ILLUSTRATIVE SITE DESIGNS
FOR
MULTI-FAMILY HOUSING IN PASADENA

Prepared for the Pasadena
Multi-Family Housing Task Force

Daniel Solomon and Associates
Daniel Solomon
Kathryn Clarke
Susan Haviland

DSA 16.4

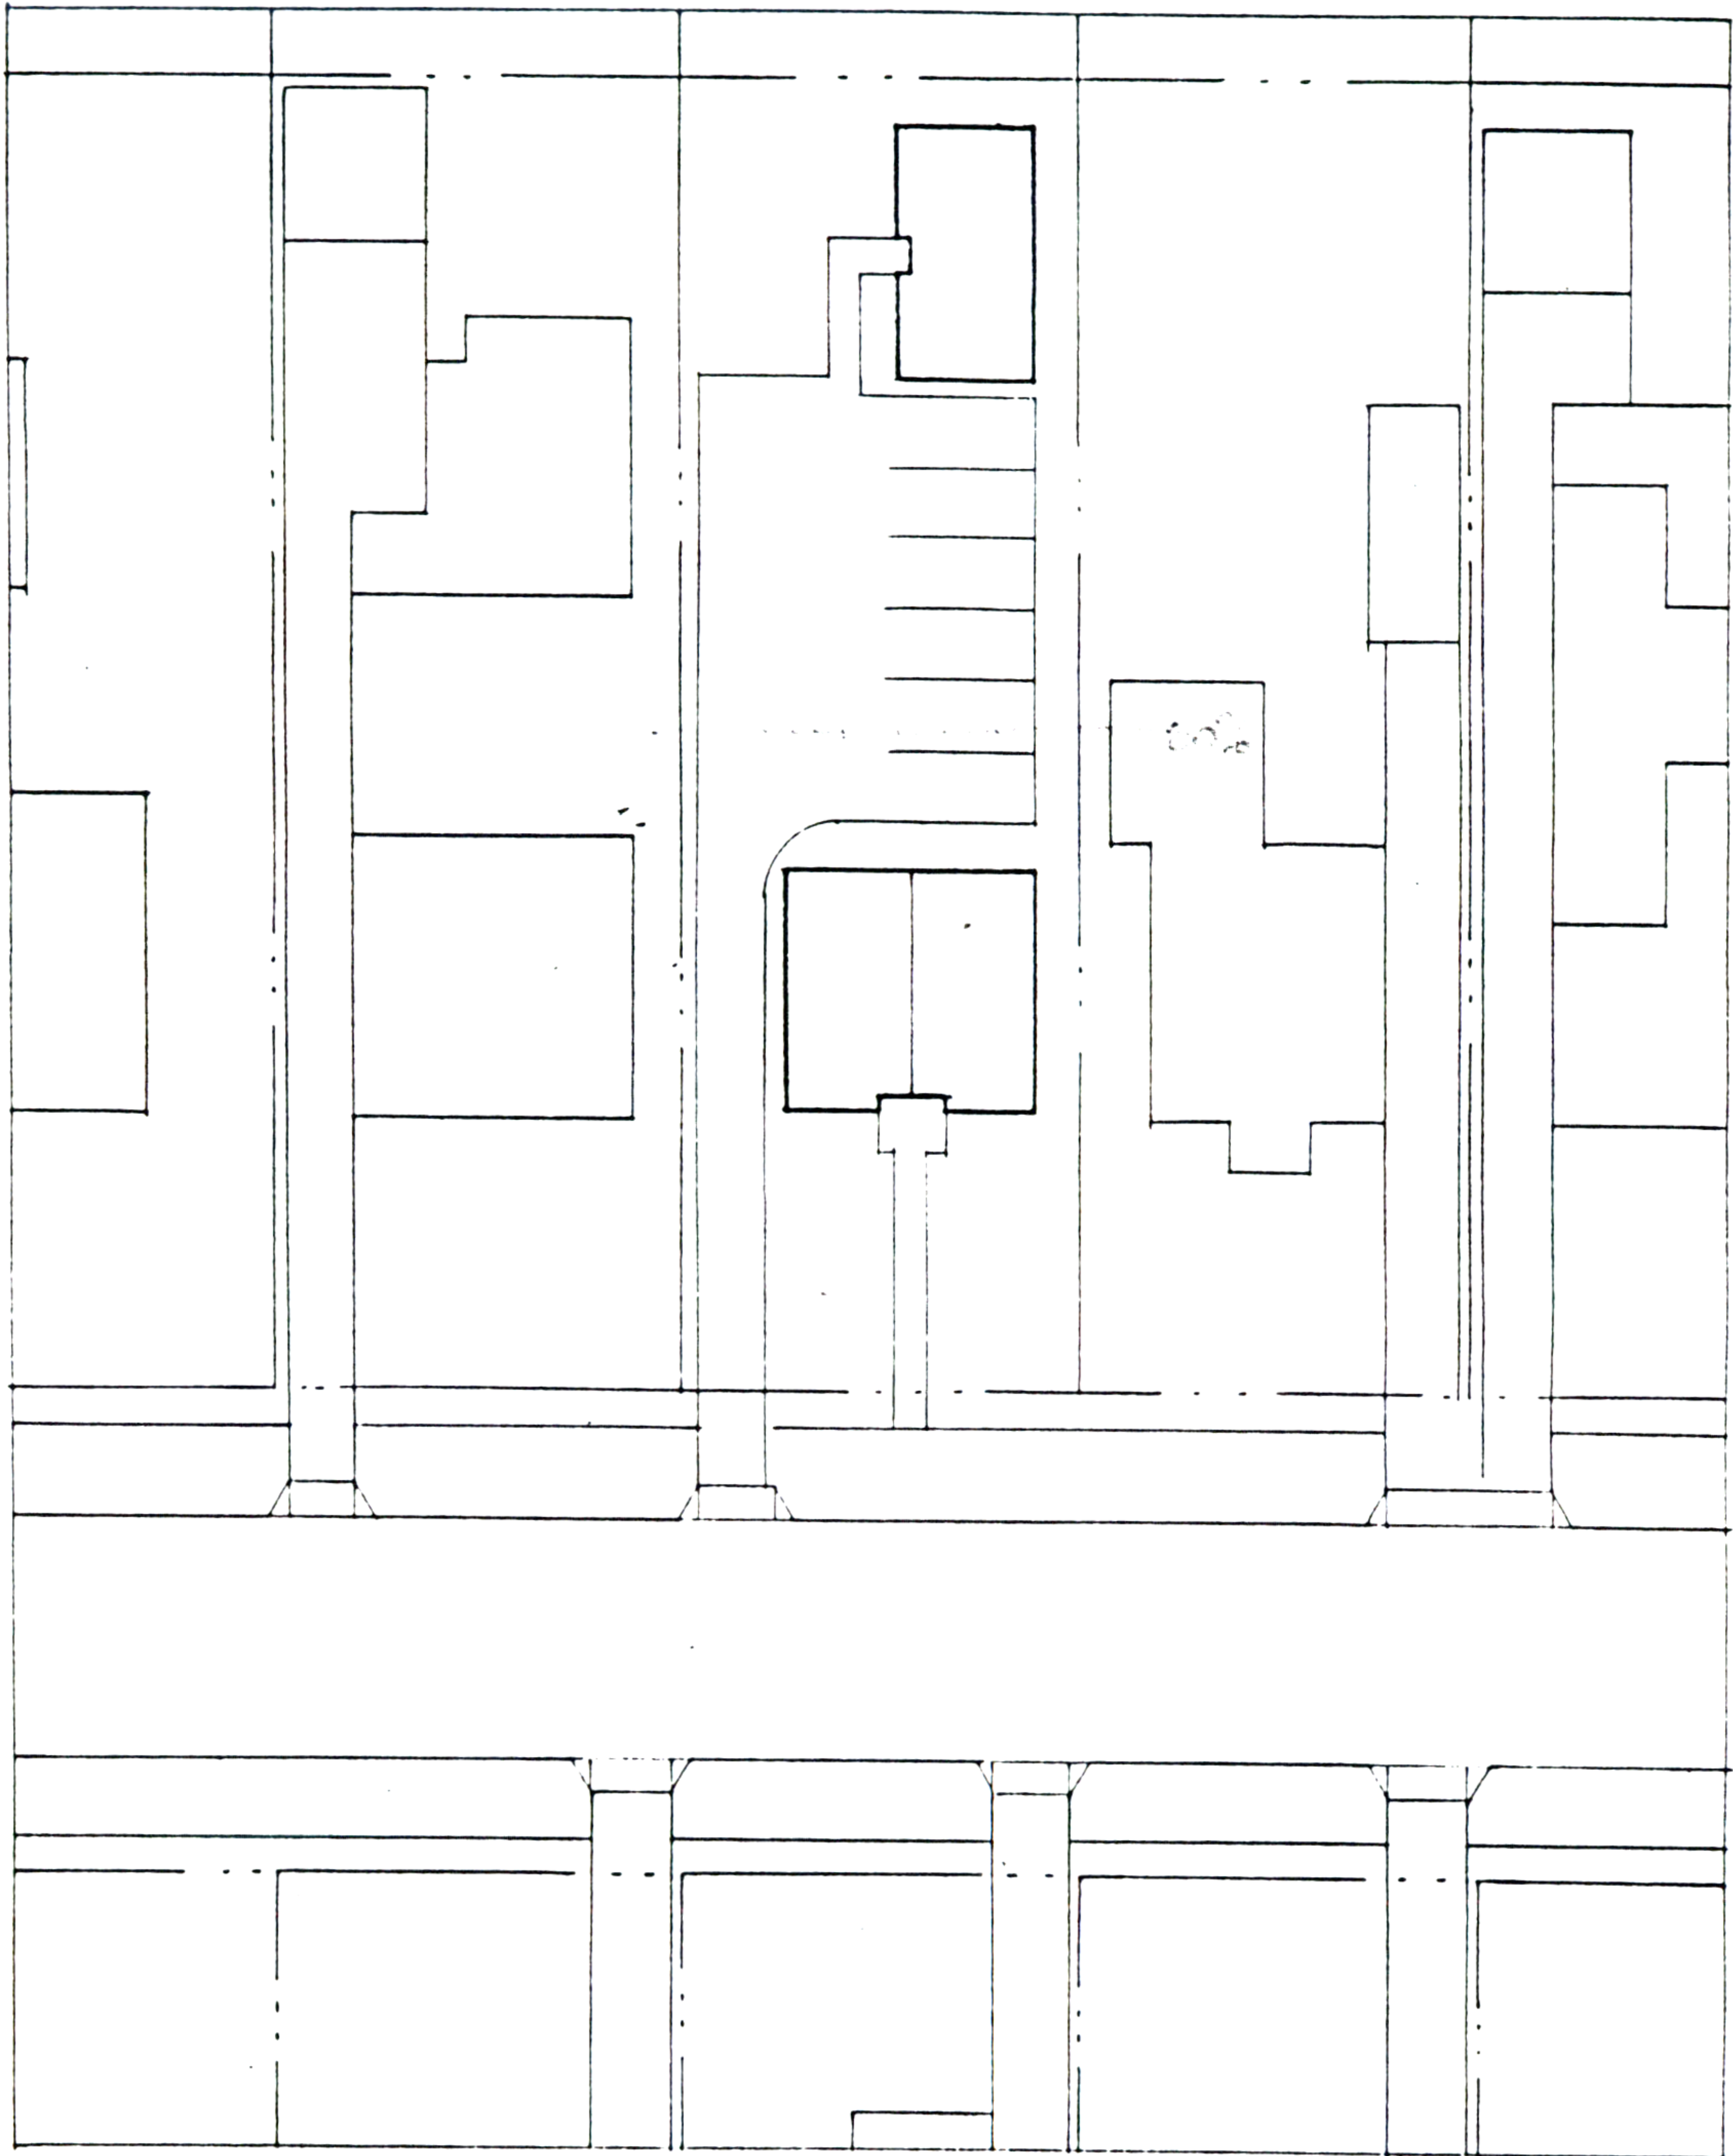
PARKING OVER REAR 50% LOT LINE!

DSA 16.6

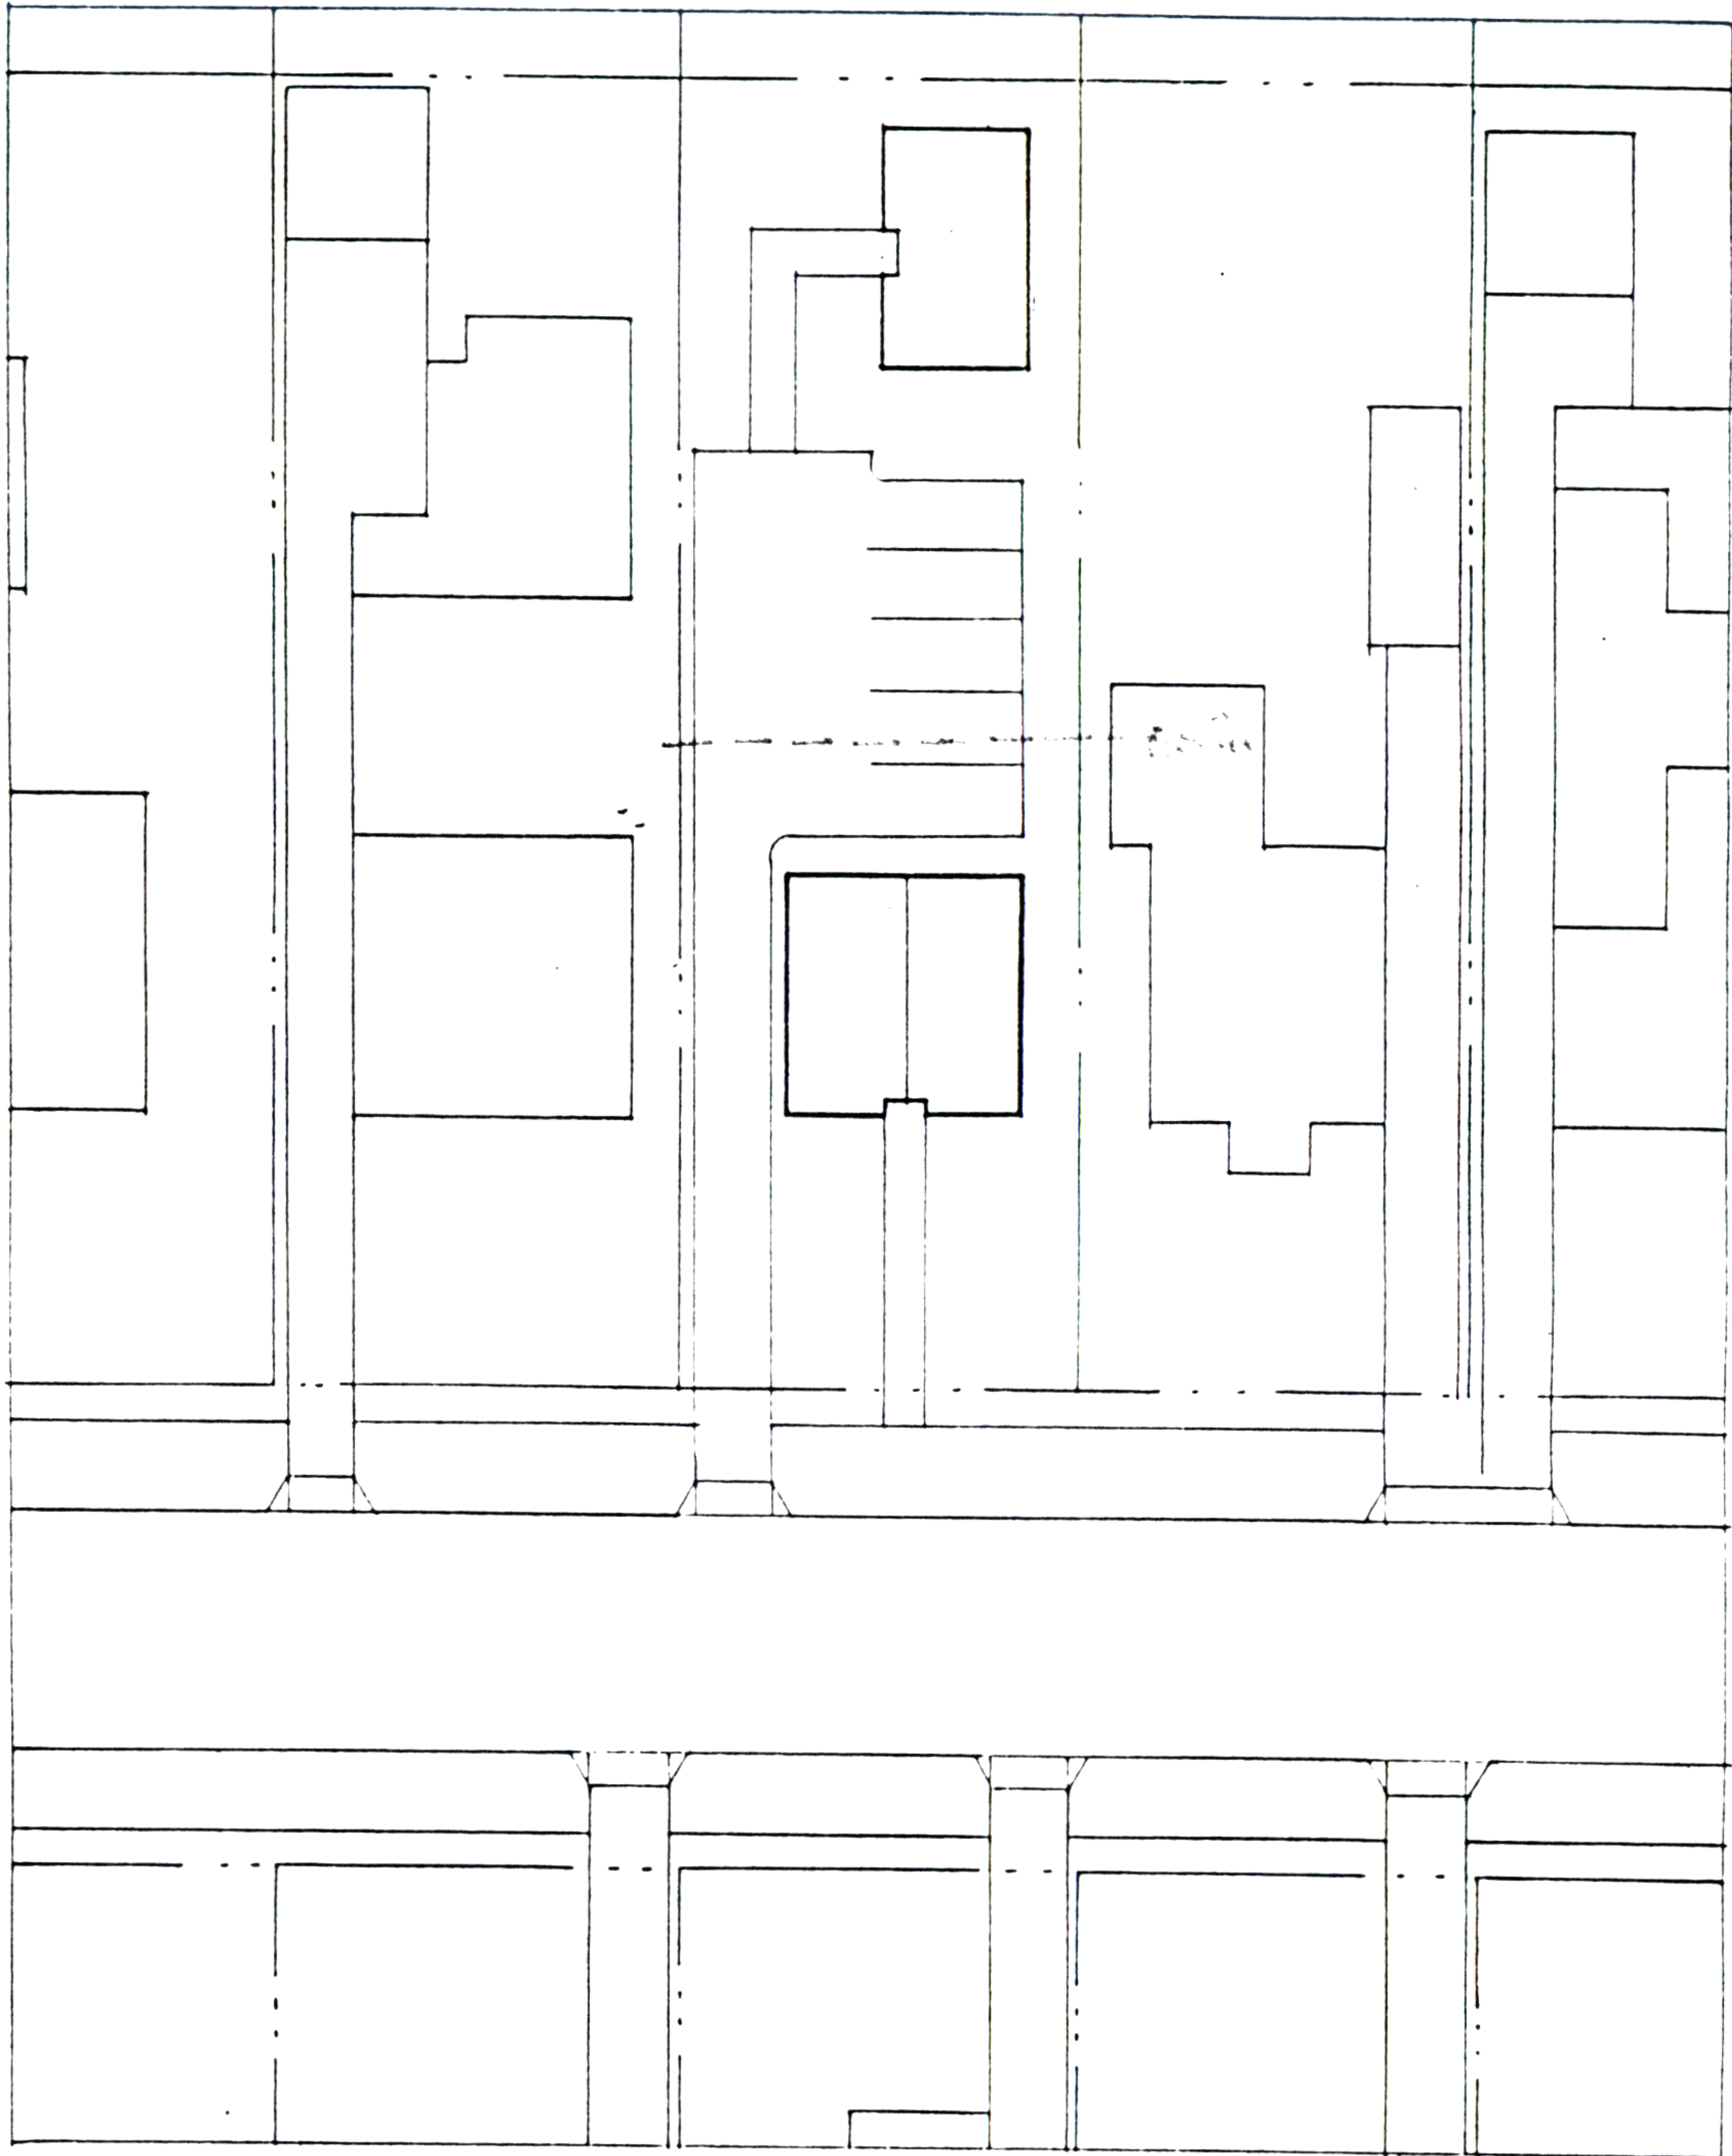
PARKING OVER REAR 50% LOT LINE!

DSA 16.8

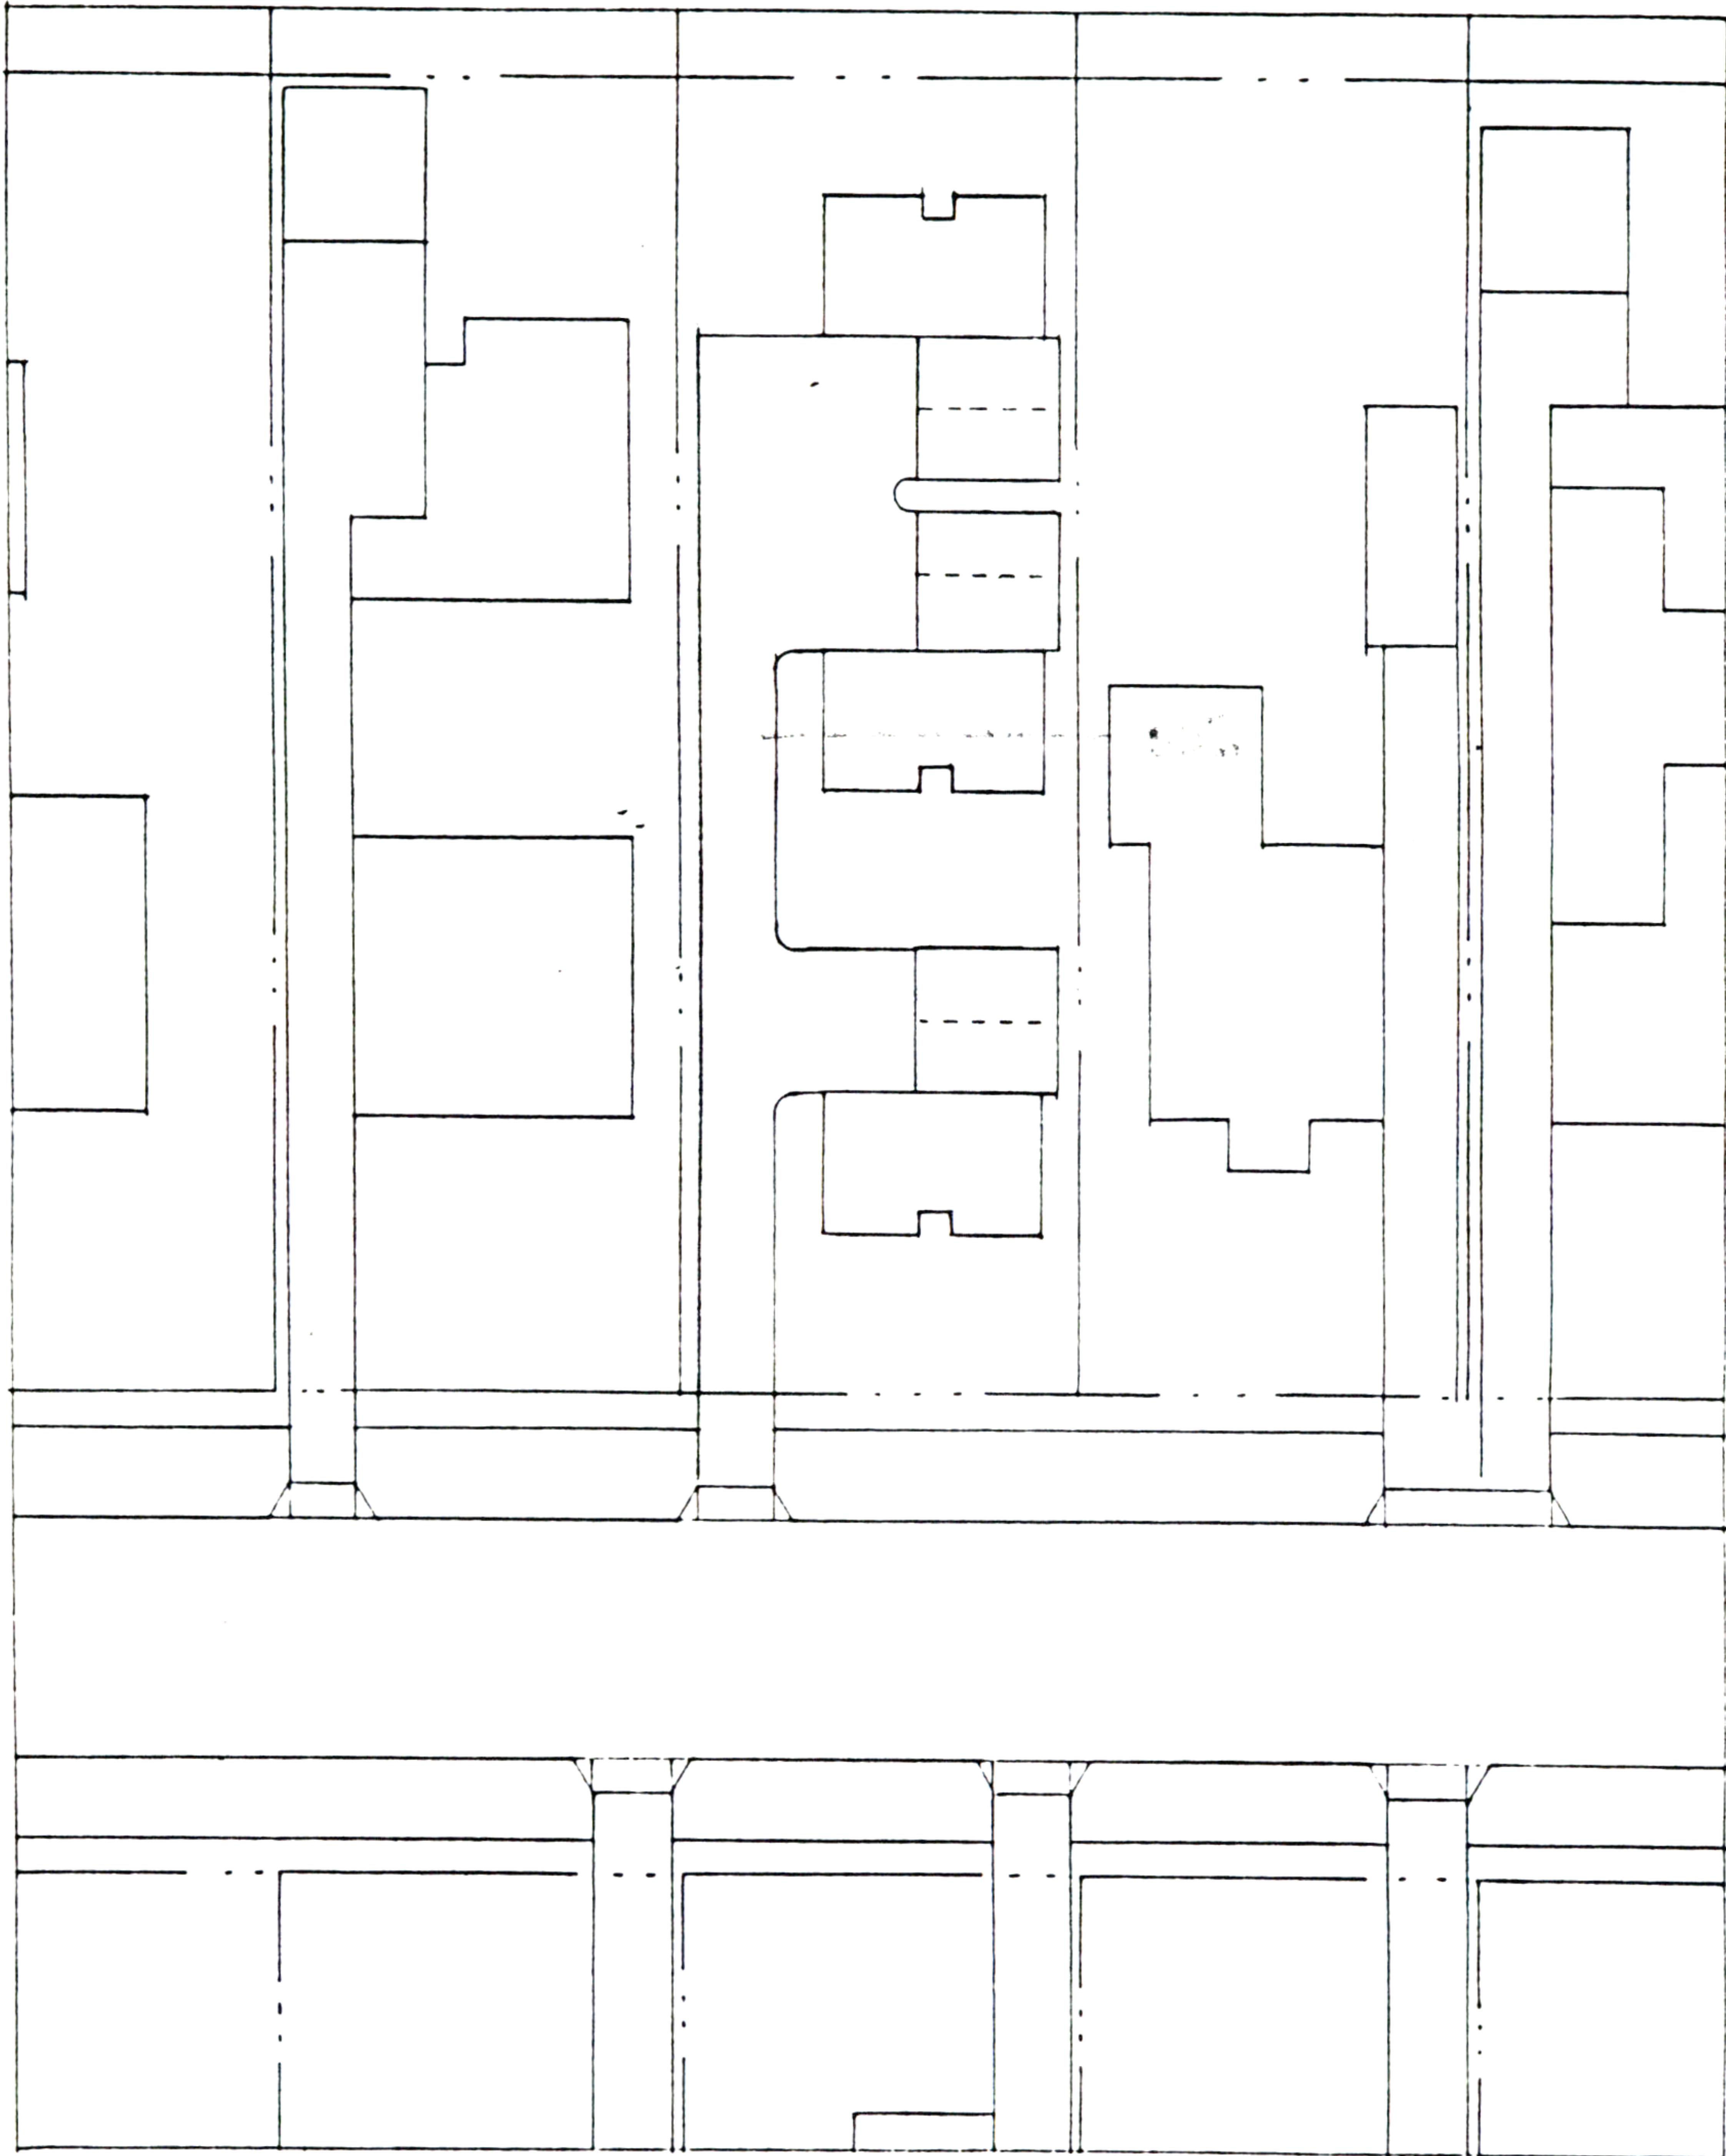
Comments: Unacceptable Scheme!

Main Garden: none!
